Report on feedback

Morrinsville Road fit for purpose upgrades

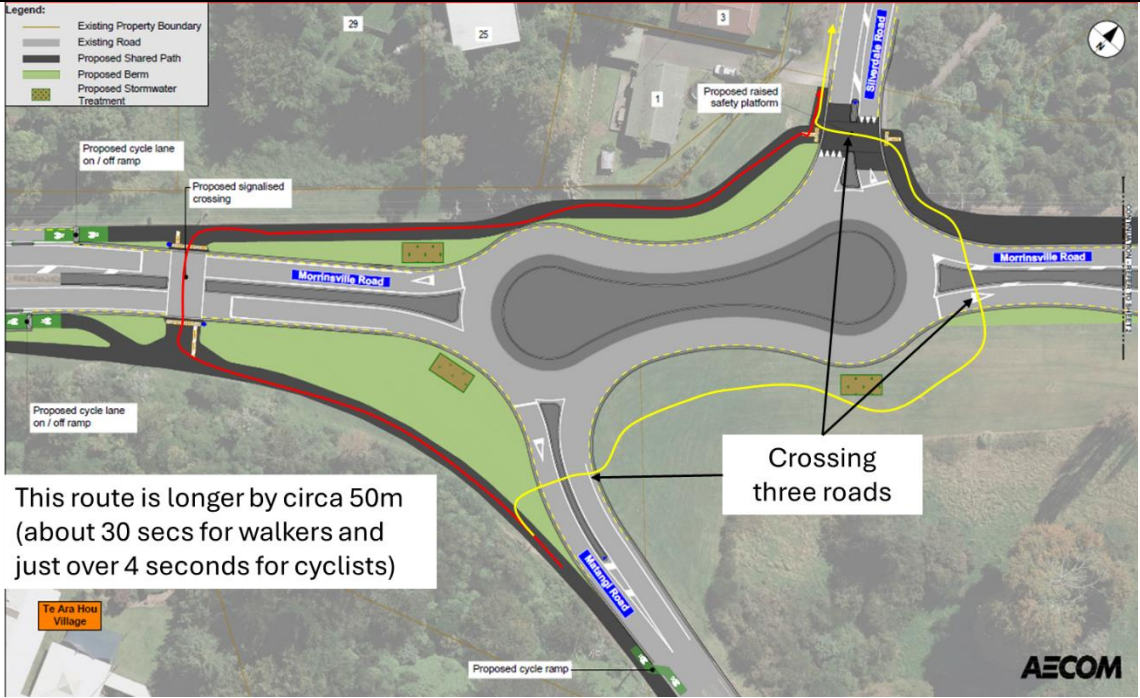
What we heard	Hamilton City Council response
	The above should reduce crashes and the severity of injuries. Wider paths and safer crossing points should also reduce crashes involving pedestrians and cyclists.
Pedestrian crossings, footpaths, cycle paths, and the shared path	
<p>There are a significant number of pedestrians (including school children) crossing Morrinsville Road to travel between Matangi Road and Silverdale Road (including heading to Hillcrest School). Two main suggestions were made regarding this situation:</p> <ul style="list-style-type: none"> • Provide a new footpath on the southeast (Matangi Road) side of the roundabout so people can walk from Matangi Road along Morrinsville Road then cross on the Morrinsville side of the roundabout. • Move the proposed signalised pedestrian crossing on Morrinsville Road closer to the roundabout, so pedestrians don't have to double back to access Silverdale Road. <p>We also received feedback that the proposed crossing was too close to the roundabout and will cause traffic queues or not be seen in time by drivers exiting the roundabout.</p>	<p>New footpath: The approach is to make the pedestrianised crossing the preferred route for the majority of pedestrians and cyclists. This is reinforced by the route being the only one that is paved and allows the pedestrian to stop the flow of traffic to cross. Using this route is slightly longer to walk but involves crossing only one road to get to the school.</p> <p>Pedestrian behaviour is influenced by a lack of dedicated crossing points, and so it may change upon implementation of the project, with better paths and safer crossing points. The figure below shows the predicted difference in travel times between the two routes.</p>

What we heard	Hamilton City Council response
	<div data-bbox="965 165 2101 866"><p>Legend:</p><ul style="list-style-type: none">Existing Property BoundaryExisting RoadProposed Shared PathProposed BermProposed Stormwater Treatment</div> <p>Pedestrian crossing location: We considered a range of locations for the pedestrian crossing, focussing on a direct and safe route for pedestrians while ensuring vehicles exiting the roundabout can easily stop before the crossing. The location we shared with the public provides the best balance between these considerations.</p>
<p>The Silverdale Road raised platform should be a zebra crossing.</p>	<p>Pedestrian priority across this road could create safety risks, as vehicles descending the hill may struggle to stop completely before the crossing. Also due to the low numbers of pedestrians and cyclists crossing in this location, drivers may stop looking for them as they approach the zebra crossing and fail to give way.</p> <p>However, if, as per the project designs, pedestrians have to give way to vehicles, the risk of crashes is reduced. Also frequent gaps in traffic provide pedestrians regular opportunities to cross Silverdale Road without requiring priority over vehicles.</p>

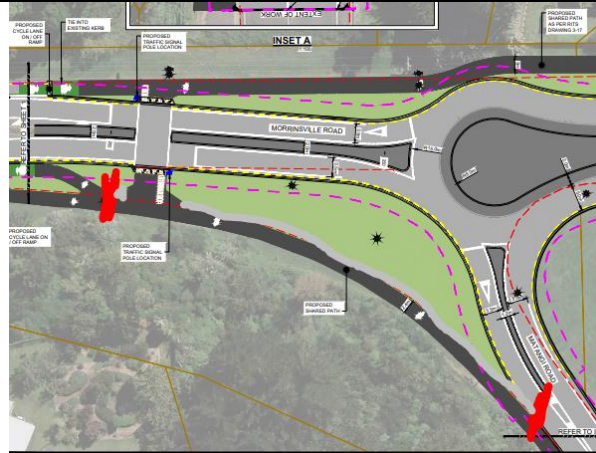
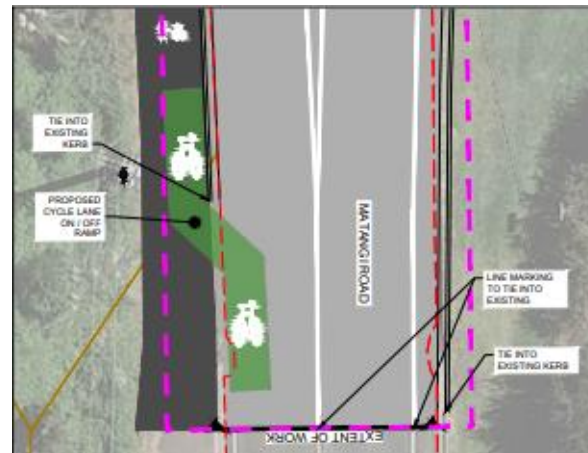
The existing path from Matangi Road to Morrinsville Road should be widened.	<p>The design has been amended to widen the existing path to 3m near the roundabout. We are not widening the section of footpath along Matangi Road further from the roundabout because there is a power pole, a bank, and a bridge restricting the ease at which it could be widened. Where the new cycle ramp joins Matangi Road the path will be remain at 2.4m wide.</p> <p>We will also remove the existing sign for trucks from the Matangi Road footpath, and around the corner on Morrinsville Road we will remove the pool fencing and relocate a street light (the next phase of this project proposes an on-road cycleway next to the footpath in this location).</p>

The design has been amended to widen the path from 2.4m to 3m between the red lines.

Path will remain at 2.4m where cycle ramp joins Matangi Road
